TECHNICAL EVALUATION REPORT
REVIEW OF TOPICAL REPORT GENE-770-06-1
"BASES FOR CHANGES TO SURVEILLANCE TEST INTERVALS AND ALLOWED
OUT-OF-SERVICE TIMES FOR SELECTED INSTRUMENTATION TECHNICAL SPECIFICATIONS"

Don R. Lasher

Idaho National Engineering Laboratory
EG&G Idaho, Inc.
Idaho Falls, Idaho 83415

Prepared for the
U.S. Nuclear Regulatory Commission
Washington, D.C. 20555
Under DOE Contract No. DE-AC07-76ID01570
FIN No. D6045

QUESTION 6
GRAND GULF LLS/RELIEF LOGIC

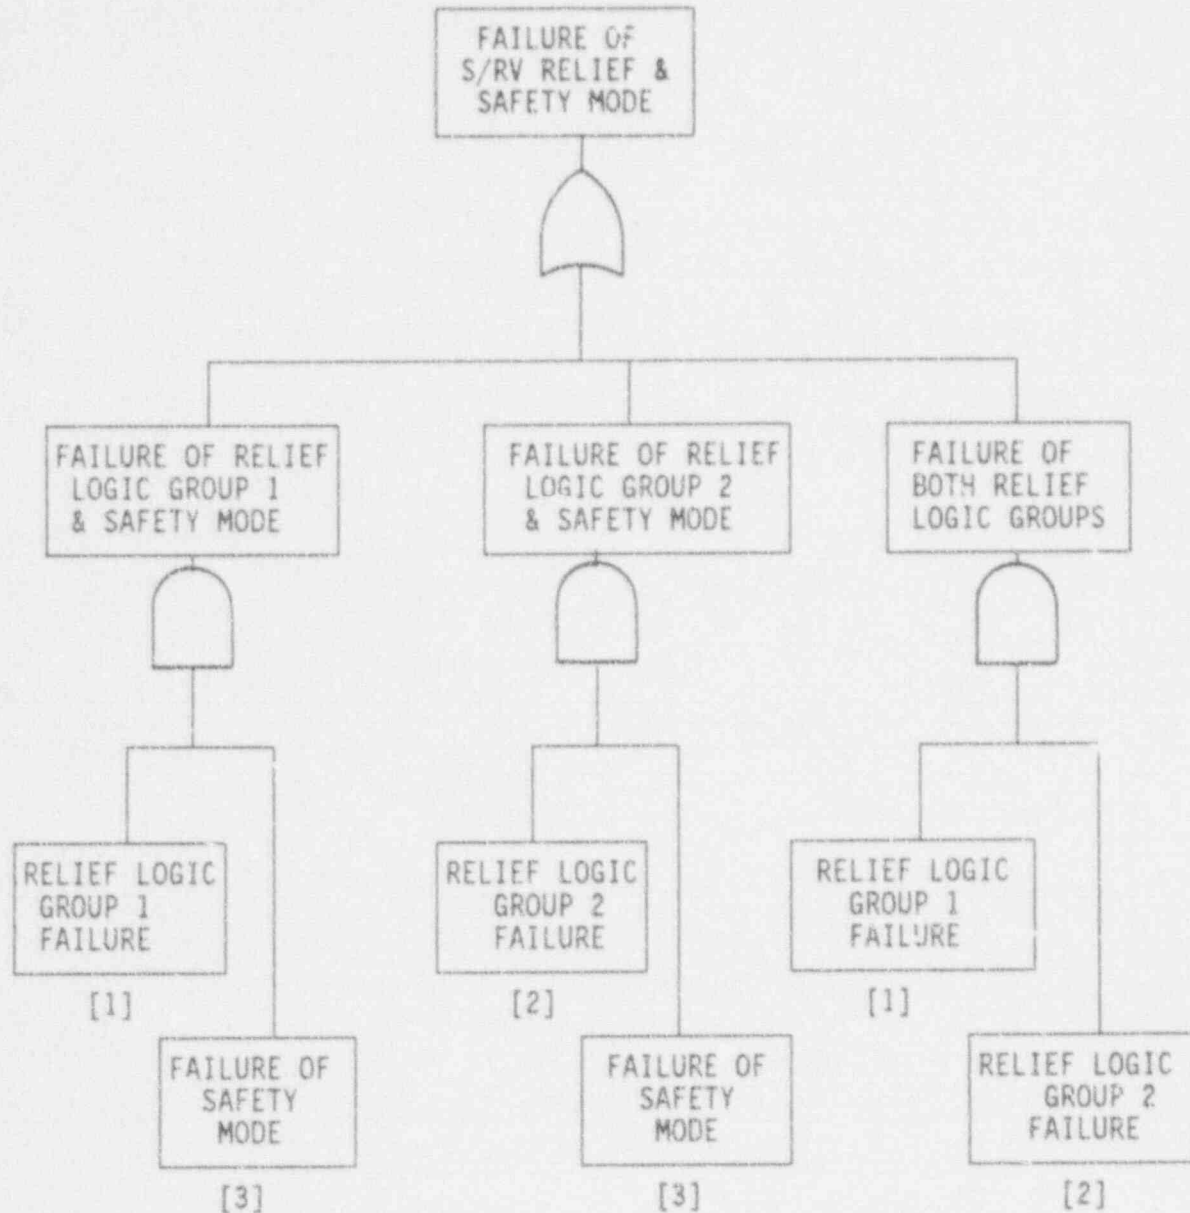
Additional information supplied by the BWROG in response to our Question Six addressed the definition of what was redundant by showing that the ASME Code allows the relief (logic actuated) and safety (spring) modes of actuation to be taken as redundant. This information also included fault trees and their evaluation to show the changes in unavailabilities which occurred when the surveillance intervals were changed from one to three months. The changes in unavailability were found to be 2.37 E-03 for the relief mode and 7.14 E-06 for the relief and safety mode which are relatively small, and the changes in surveillance intervals and allowed out-of-service times for testing are comparable to those granted for other similar systems. We therefore conclude the change in surveillance intervals from one to three months and the inclusion of a six hour AOT for testing are acceptable.

For the BWR 6 lead plant 13 of the 20 S/RVs are required to prevent reactor overpressure. The S/RVs are designed to limit the primary system pressure, including transients, to the requirements of the ASME Section III. The ASME code allows one-half of the S/RVs to open in the safety (spring) mode and one-half to open in the pressure relief mode.

Enclosure 6 provides a description of the pressure relief logic. One group of 9 S/RVs are actuated by 1 out of 2 logic Divisions. Each Division is actuated by tripping 2 out of 2 reactor pressure trip unit channels. A second group of 10 S/RVs are tripped by another set of reactor pressure trip units using a similar logic configuration. One S/RV is tripped by a third set of reactor pressure trip units. As discussed in response (5), 6 of the 20 S/RVs also have a LLS function in addition to the pressure relief function. The LLS seal in logic uses the same trips units as the pressure relief logic. Because of this commonality, no credit was taken for the LLS relief mode when calculating the pressure relief function unavailability.

A fault tree model of failure of the S/RV relief and safety mode at the logic channel level is provided in Enclosure 6. The unavailability was calculated using trip unit failure rates from original design analyses and failure rates that reflect more current operating experience. The calculated change in relief and safety mode unavailabilities when the surveillance test interval is extended from 1 to 3 months is approximately $7E-06$ /demand based on failure rates from the original design analysis and $4E-08$ /demand based on failure rates reflecting

QUESTION 7 PLANT SYSTEMS ACTUATION
A) BWR 6 CONTAINMENT SPRAY

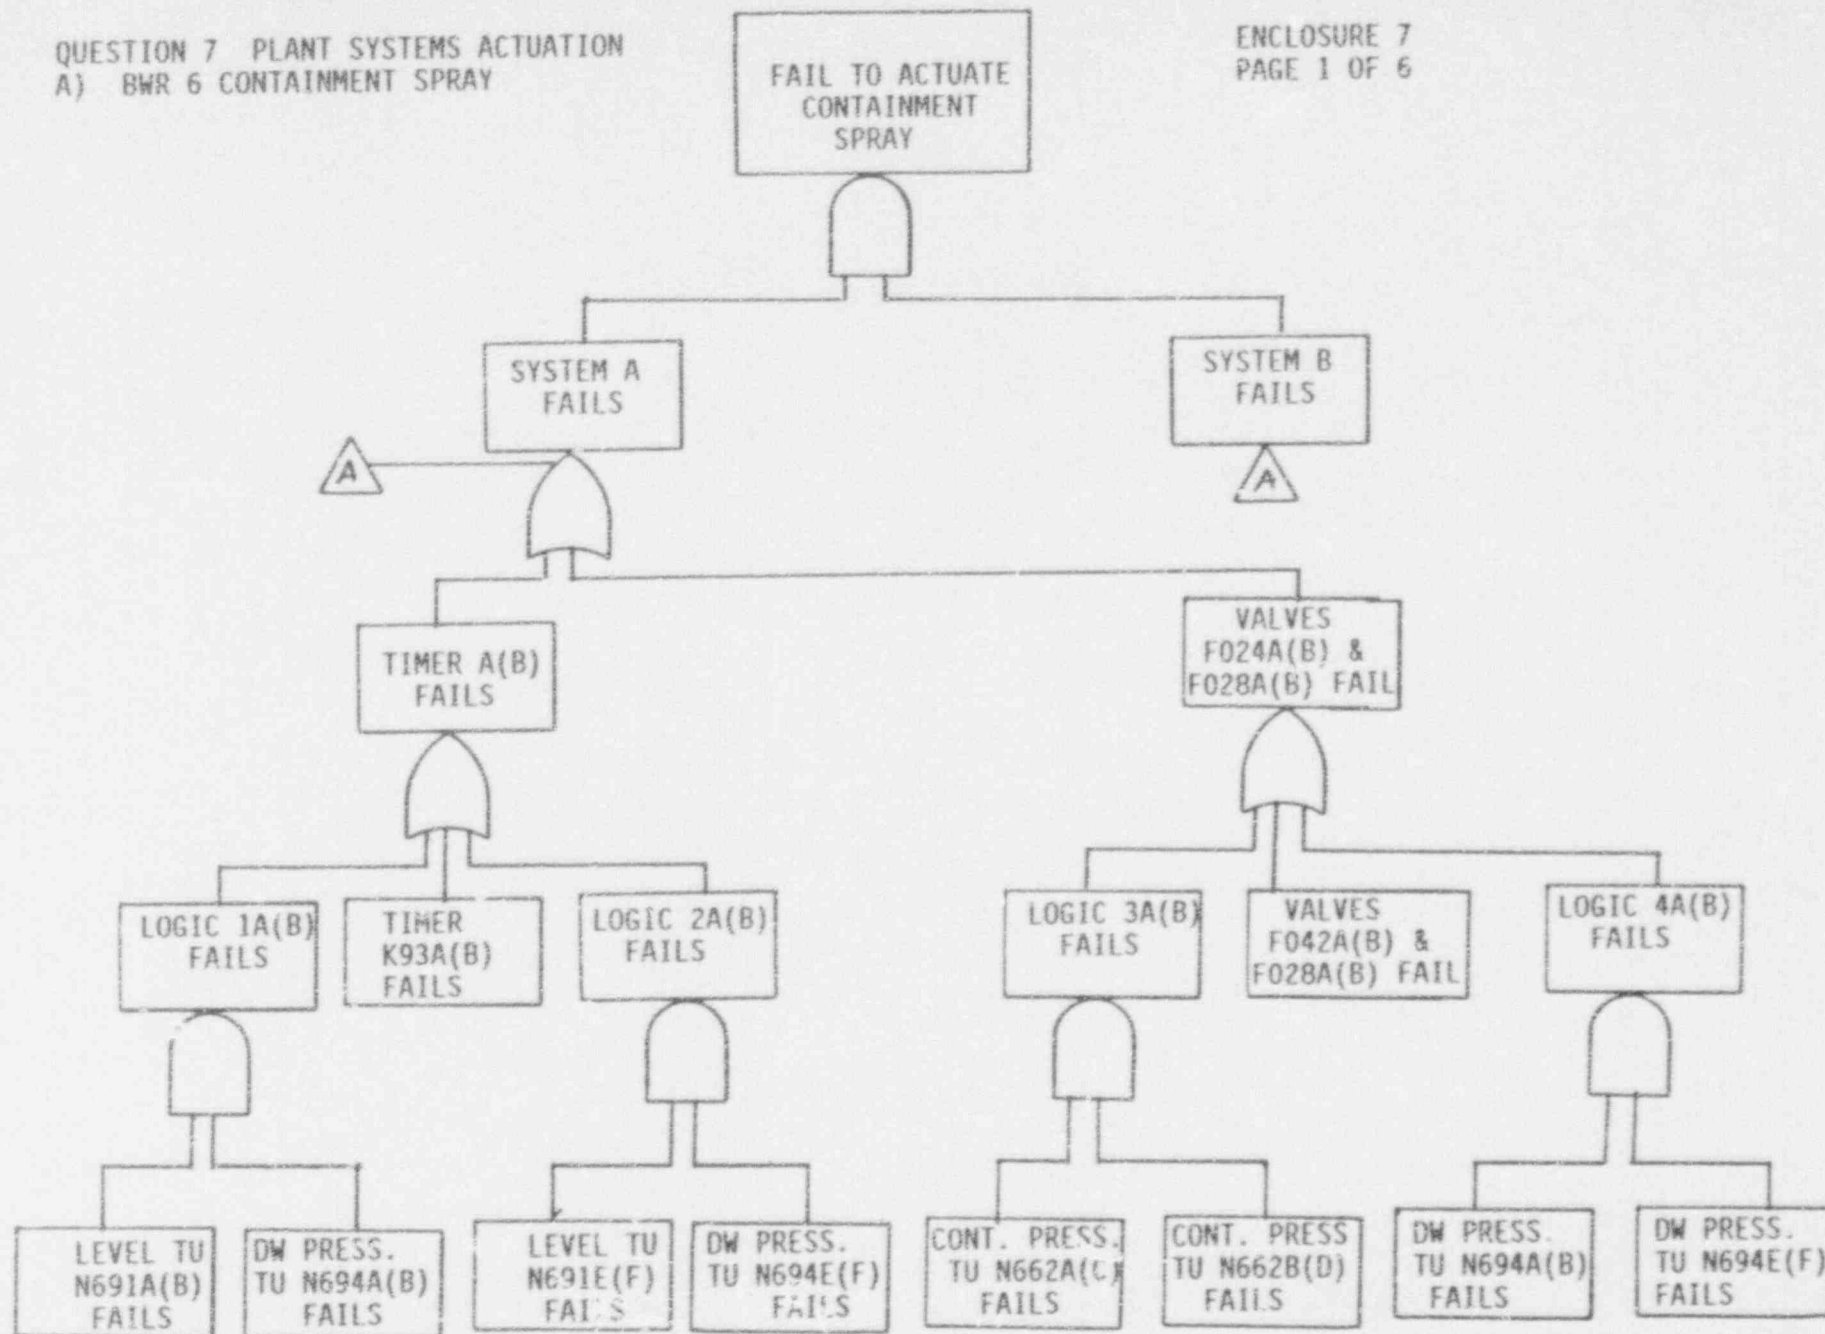
For the BWR6 Plant Systems Actuation Instrumentation (RHR Containment Spray System, Feedwater & Main Turbine Trip- System, and Suppression Pool Makeup System Instrumentation) provide a more specific reference system to which each of these three systems can be compared. Also provide additional information describing the valve unavailability analyses and results.

A fault tree of the containment spray initiation including the valves that have to open and close is presented in Enclosure 7. The unavailability was calculated as a function of the level/pressure trip channel surveillance interval for a single trip system and 1 out of 2 trip systems. Using a level/pressure trip channel failure rate based on current experience, the change in calculated unavailability when the surveillance interval is extended from 1 to 3 months is $8.75E-05/\text{demand}$. No credit is taken here for manual actuation if the automatic initiation logic should fail. This small increase in calculated unavailability is insignificant and is offset by the similar benefits of reduced testing discussed in Section 4.2 of the ECCS Actuation Instrumentation Analysis, Reference 4.

BWR 4 MCRECS INSTRUMENTATION

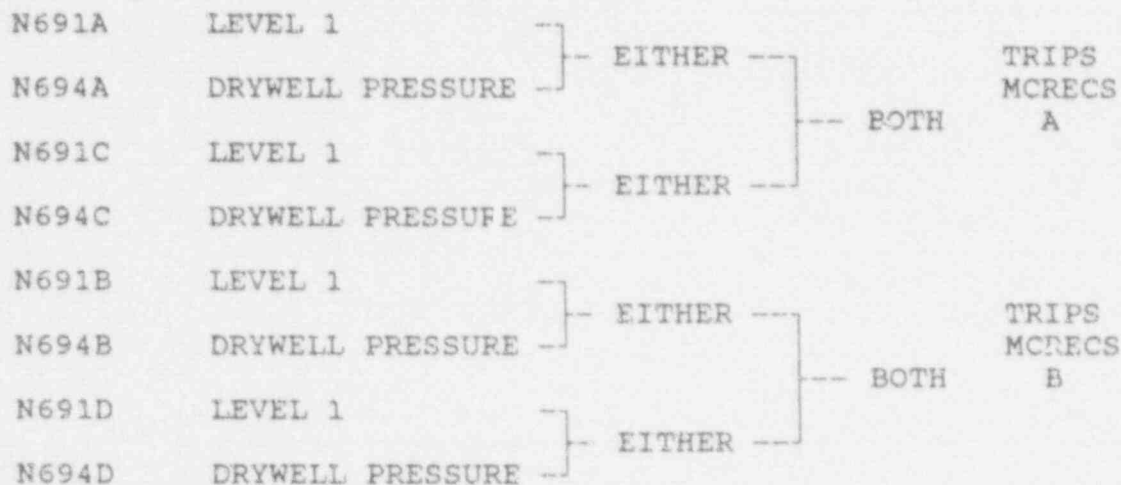
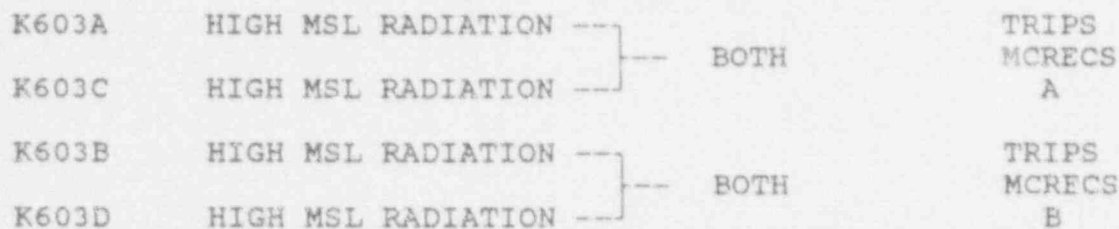
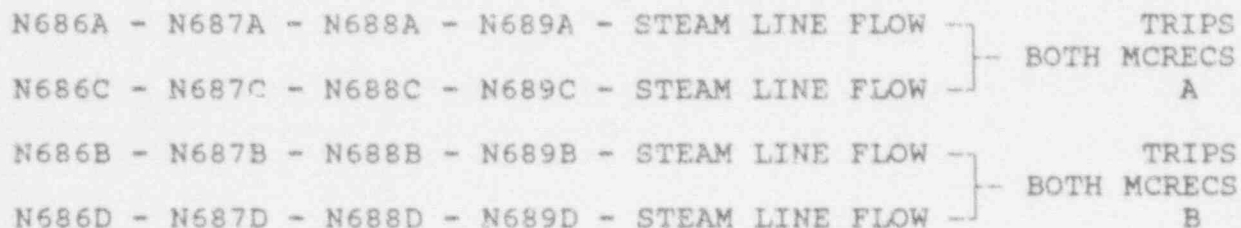
The reference given for the reactor vessel water level 1, high drywell pressure, and main steam line high flow inputs to the MCRECS was not acceptable because it did not appear to provide analyses against which to compare the reactor vessel water level 1 and main steam line high flow inputs. Further, in the basis, such a comparison was not made and initiation of MCRECS was not addressed.

The current basis should also provide additional information on how the high control room and the refueling floor area radiation functions are similar to the reactor building exhaust high radiation function to enable judgement to be made as to whether the fault trees and their evaluation are applicable to the high control room and the refueling floor area radiation functions. Additional information provided by the BWROG in response to our Question Eight addressed our concerns by providing, for each of six initiating events, the applicable logic configuration per subsystem, references to previously reviewed actuation instrumentation, and logic diagrams. Each subsystem was shown to be similar to a previously analyzed system, thus the change in unavailabilities previously calculated for that system should also apply to this system. References were also provided to similar previously reviewed systems for the Refueling Floor Area High Radiation, Control Room Inlet High Radiation, and Control Room Inlet High Chlorine Level Function actuation instrumentation. The small increases in unavailability previously calculated for the referenced systems were found acceptable for justifying similar changes in surveillance intervals and AOTs for those systems. Therefore, by similarity, they will also be acceptable justification for the requested similar changes in surveillance intervals and AOTs for the MCRECS actuation instrumentation.

For the BWR4 Main Control Room Environmental Control (MCREC) Actuation Instrumentation, please provide specific references for the reactor vessel water level 1, high drywell pressure, and main steam line high flow inputs to the MCREC systems. The quoted reference did not address the water level 1 and main steam line high flow inputs. More specific references should be provided for the MCREC inputs and the similarities in configuration, components and qualification addressed to allow comparison to be made and conclusions drawn. Also, please provide additional information on how the high control room and the refueling floor area radiation functions are similar to the reactor building exhaust high radiation function to enable judgement to be made as to whether the fault trees and their evaluation are applicable to the high control room and the refueling floor area radiation functions.

The logic that initiates MCREC is similar to the logic given in the case studies for BWR plants. Instead of closing an inboard and outboard valve, the logic initiates redundant MCREC subsystems. The logic therefore is analogous to the logic given under the column headed "Logic Type Per Valve Per Variable". The only exception is the logic for a LOCA signal. The trip units and logic for the LOCA signal is the same signal that actuates the ECCS low pressure systems analyzed in Reference 5. The LOCA signal is also similar to the 1 out of 2 twice logic in Reference 6 except there are 2 variables instead of 4.
